## Addendum #2

### Questions and Answers

**PORT OF ASTORIA**  
 PIER 1 WEST INTERIM FENDER SYSTEM  
 ASTORIA, OR  
 INTERIM FENDER SYSTEM DETAILS

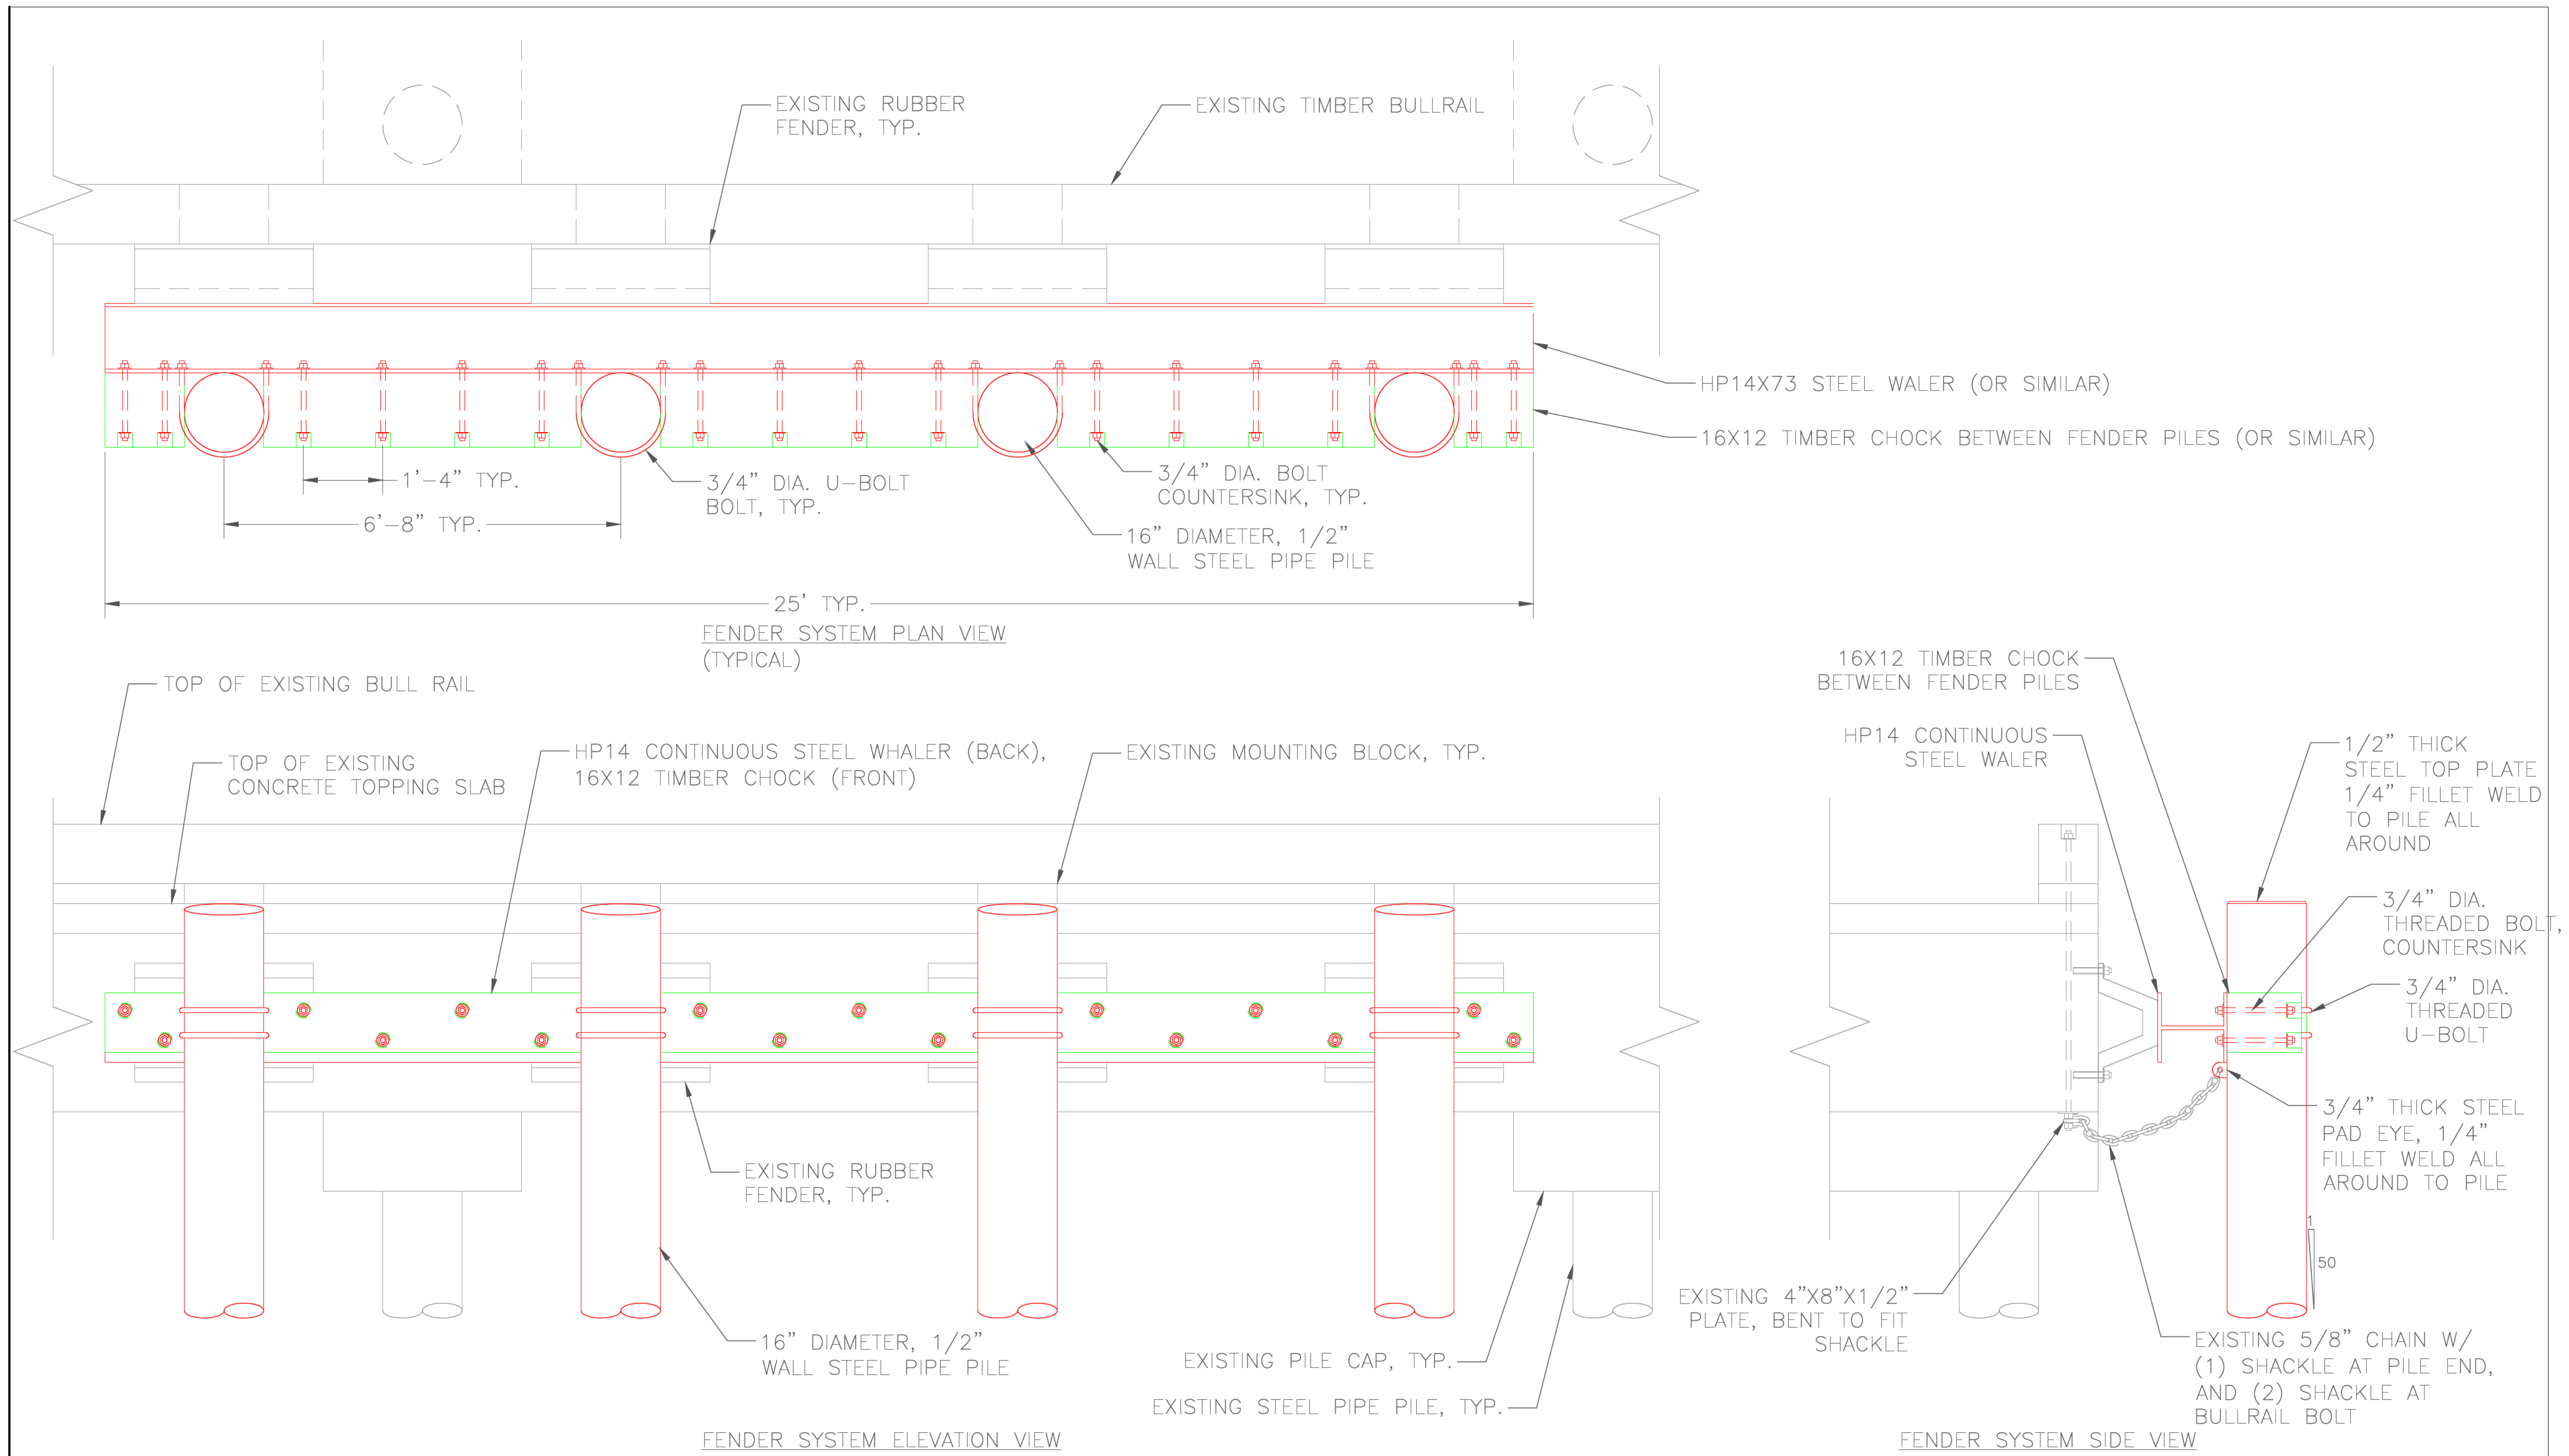
1. Will the port dispose of the wood piling, timber blocking and steel pile cut-offs?  
Yes
2. Will the contractor furnish the steel pile?  
Yes
3. Is there any detail available for the design of the weld caps for the Pier 1 West piling?  
Weld caps shall be 16" diameter, .50" thickness, flat/stove top style as shown below.
